Rezoning Transportation Analysis

Petition Number: 2020-173

General Location Identifier: Tax ID 02919113

Date	Description
12-28-20	First Review (EL)

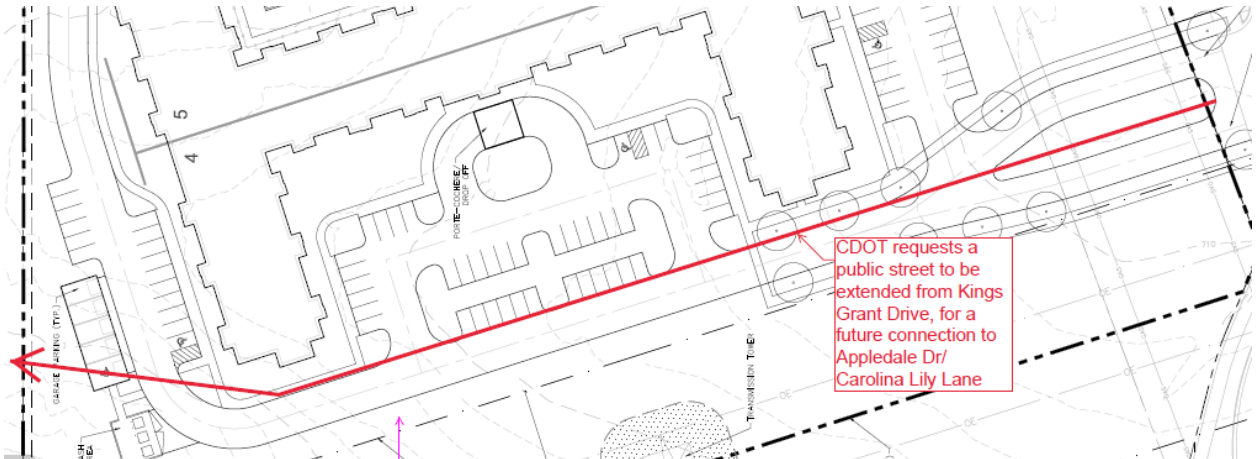
Provide comments to the specified comments below.

2. Revise site plan and conditional note(s) to commit to construct a public street extension from Kings Grant Drive, for a future connection to Appledale Drive/Carolina Lily Lane.

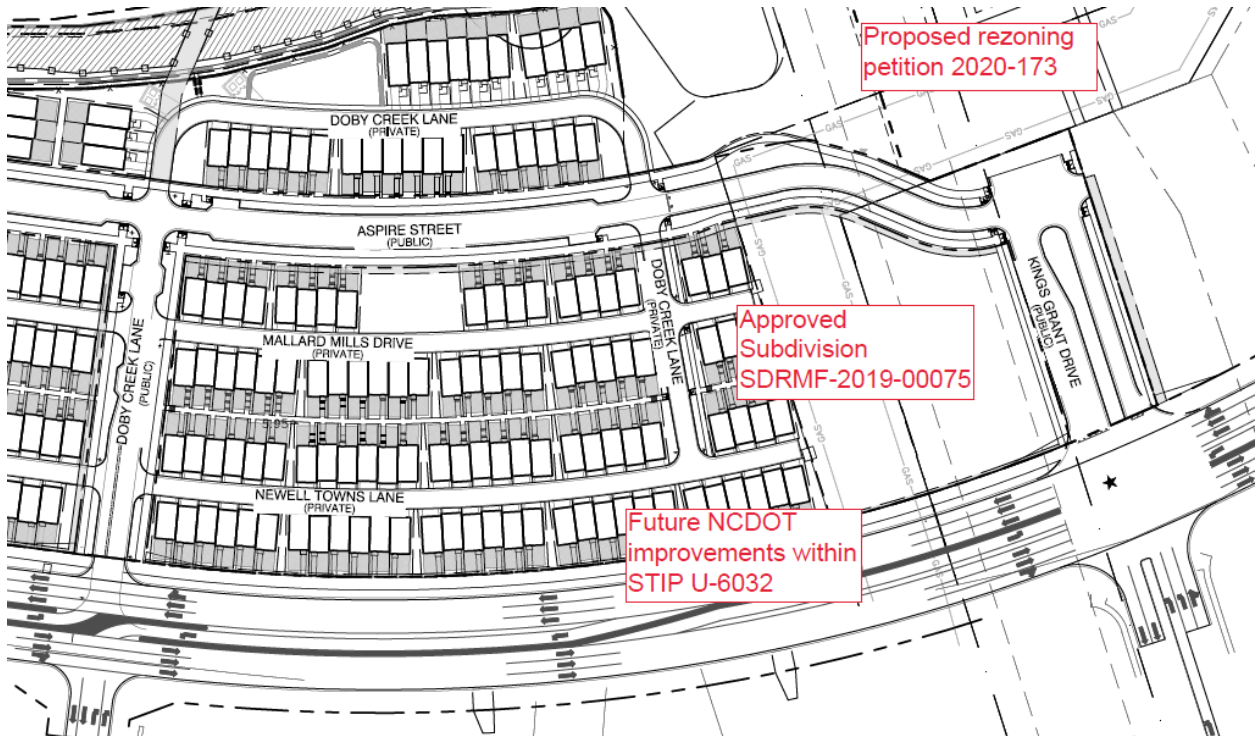
4. In coordination with NCDOT, revise site plan and conditional note(s) to clarify how the proposed access will be provided to this rezoning petition's landlocked parcel, if approved **SDRMF-2019-00075 - Mallard Creek Townhomes**, within **rezoning petition 2018-067**, is not developed to provide access off the proposed public Aspire Street.

Kings Grant Drive, north of Mallard Creek, will not tie-into Mallard Creek, since the NCDOT's State Transportation Improvement Program (STIP) U-6032 project has been delayed for construction until 2025. STIP U-6032's scope will improve the Kings Grant Drive and Mallard Creek Road intersection with a signal. Kings Grant Drive improvements, to be installed by **Mallard Creek Townhomes**, north of Mallard Creek Road, will stop short of Mallard Creek Road as an interim condition.

NCDOT will require interim improvements on Mallard Creek Road, if the petitioner desires access off Kings Grant Drive should the proposed Aspire Street not be constructed by others. CDOT recommends the petitioner coordinate with NCDOT to determine the required interim improvements on Mallard Creek Road as a plan for this scenario.
